LOCAL DEVELOPMENT PLAN 2

Part 1 Wind Energy Development: Development Management Considerations Appendix 'C' Dumfries & Galloway Wind Farm Landscape Capacity Study

Revisions to guidance adopted June 2017

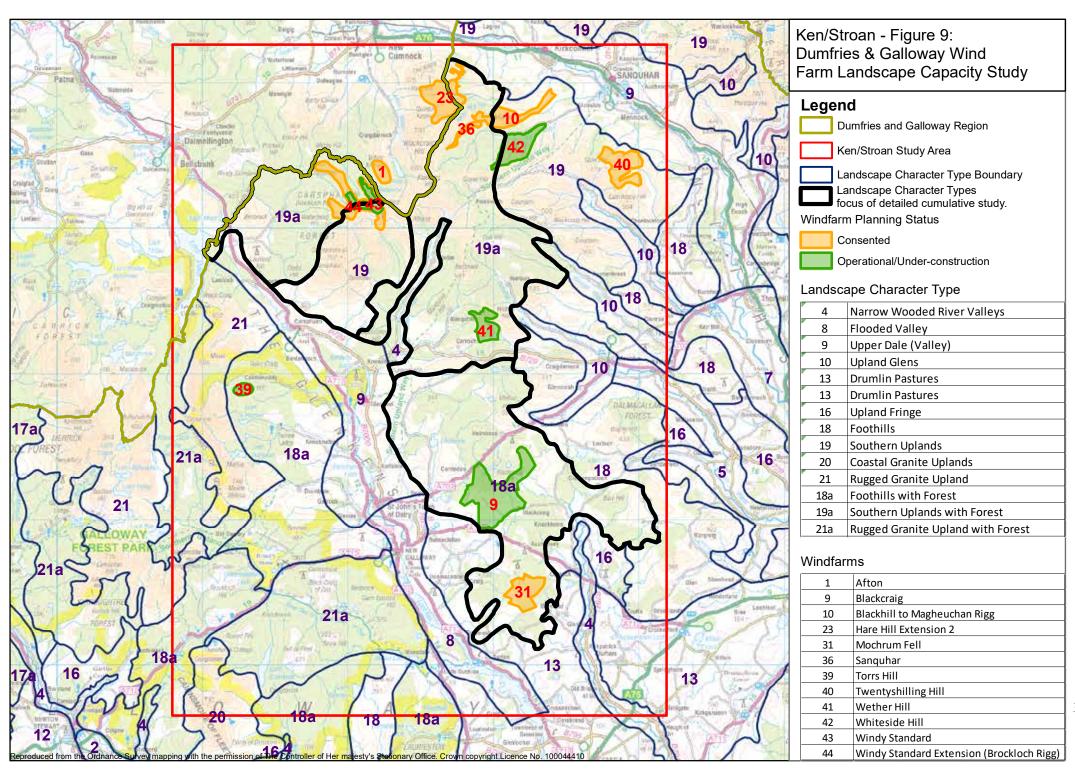
30	3.4.1 Paragraph 4; bullet point 2	The first sentence has been revised as follows, including adding the following text (in red); 'There may be some very limited scope for a small number of additional Large turbines (80-150m). However, this will be constrained by potential effects on the Merrick WLA, on the remaining more extensive areas of open moorland in the south of this area at the transition between LCTs 17/17a and 16 which are rich in archaeology and are a diminishing landscape feature in Dumfries and Galloway'
30	3.4.1 Paragraph 5;	Final paragraph 'The study concludes' shouldn't be a bullet point. The following text has been added (in red) to final sentence; 'Turbines up to 200m may be able to be accommodated in repowering, although this will be dependent on redesign of the wind farm layout to avoid significantly exacerbating existing landscape and visual effects.
35	Figure 9	The focus of detailed study included the Carsphairn unit of 19a; Figure 9 has been amended to show the correct boundary.

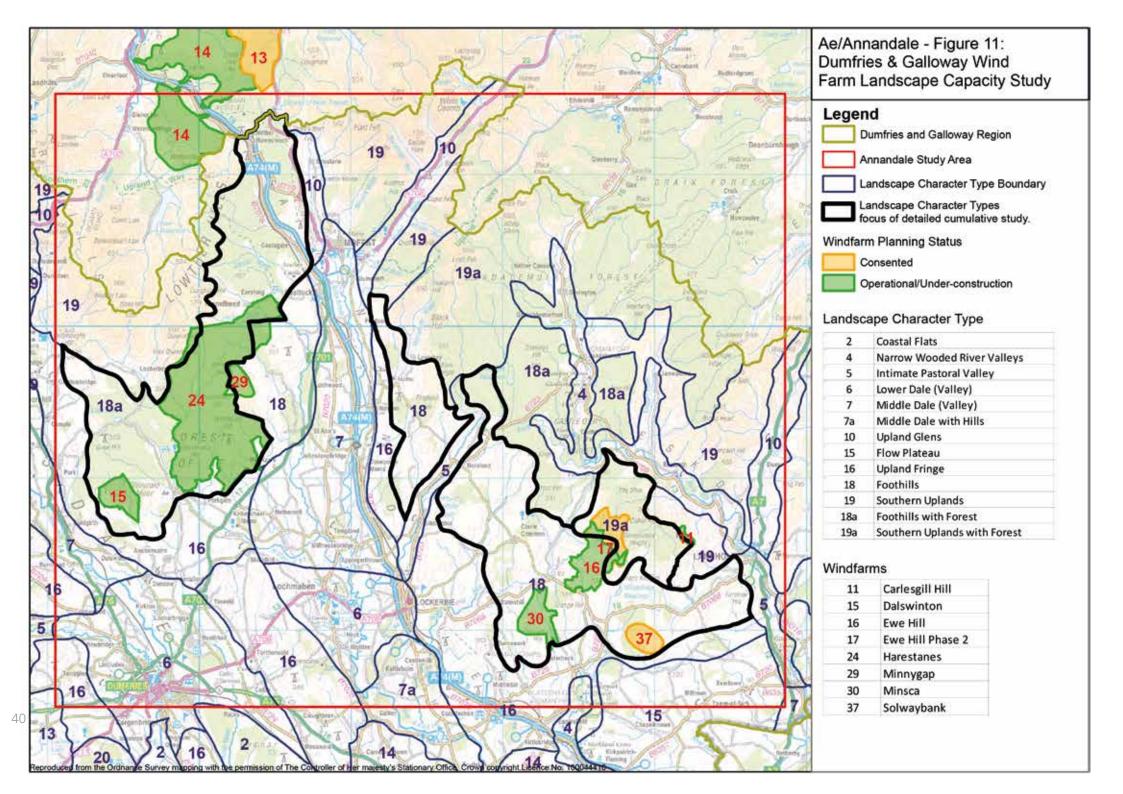
40	Figure 11	Existing/consented windfarms should have been shown on Figure 11; they have now been amended.
